Intersection ID: 18728	Main Street: RANDOLPH_RD	Cross Street: WONDERWOOD_DR	Location:	SW
ADA ID: 9F6A796A95B2	Ramp Type: Perp	Initial Pass/Fail: Fail	Overall Compliance: No	Severity Score: 13.75

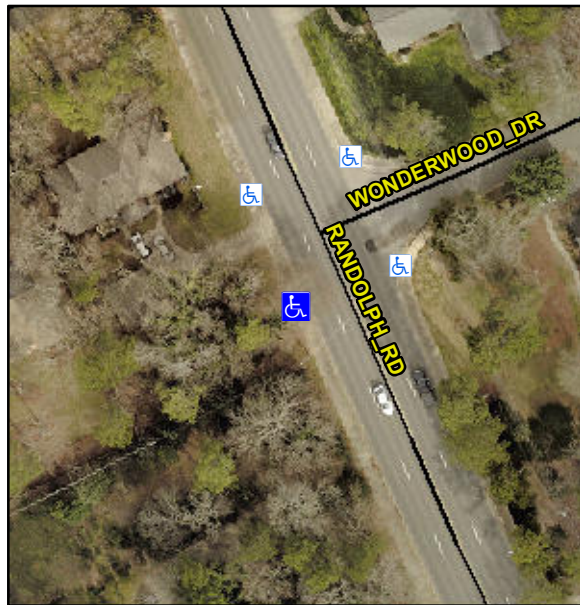
Not Found, R304.2.2, R304.5.3

Compliance	Description	Data	Compliance	Description	Data
N/A	Ramp Length (in)	71.5	No	Ramp Slope (%)	11.2
Yes	Ramp Width (in)	48.0	No	Ramp XSlope (%)	2.6
N/A	Flare Type LT	N/A	N/A	Flare Type RT	N/A
N/A	Flare Slope LT (%)	N/A	N/A	Flare Slope RT (%)	N/A
N/A	Flare Traversable LT?	N/A	N/A	Flare Traversable RT?	N/A
N/A	Landing Length (in)	N/A	N/A	DWS Provided?	N/A
N/A	Landing Width (in)	N/A	N/A	DWS Contrast?	N/A
N/A	Landing Slope (%)	N/A	N/A	DWS Length (in)	N/A
N/A	Landing X Slope (%)	N/A	N/A	DWS Full Width?	N/A
N/A	Landing Curb? (Y/N)	N/A	N/A	DWS Offset (in)	N/A
N/A	Shared Landing?	N/A			
N/A	Gutter Ponding?	Yes	N/A	Gutter Slope (%)	N/A
N/A	Gutter Lip Ht (in)	N/A	N/A	Gutter X Slope (%)	N/A
N/A	Painted X Walk1?	No	N/A	Painted X Walk2?	N/A
	X Walk 1 Direction	To E		X Walk 2 Direction	N/A
N/A	X Walk 1 Width (in)	N/A	N/A	X Walk 2 Width (in)	N/A
	X Walk 1 Slope (%)	0.6		X Walk 2 Slope (%)	N/A
	X Walk 1 X Slope (%)	0.2		X Walk 2 X Slope (%)	N/A

Remove & Replace Entire Ramp.
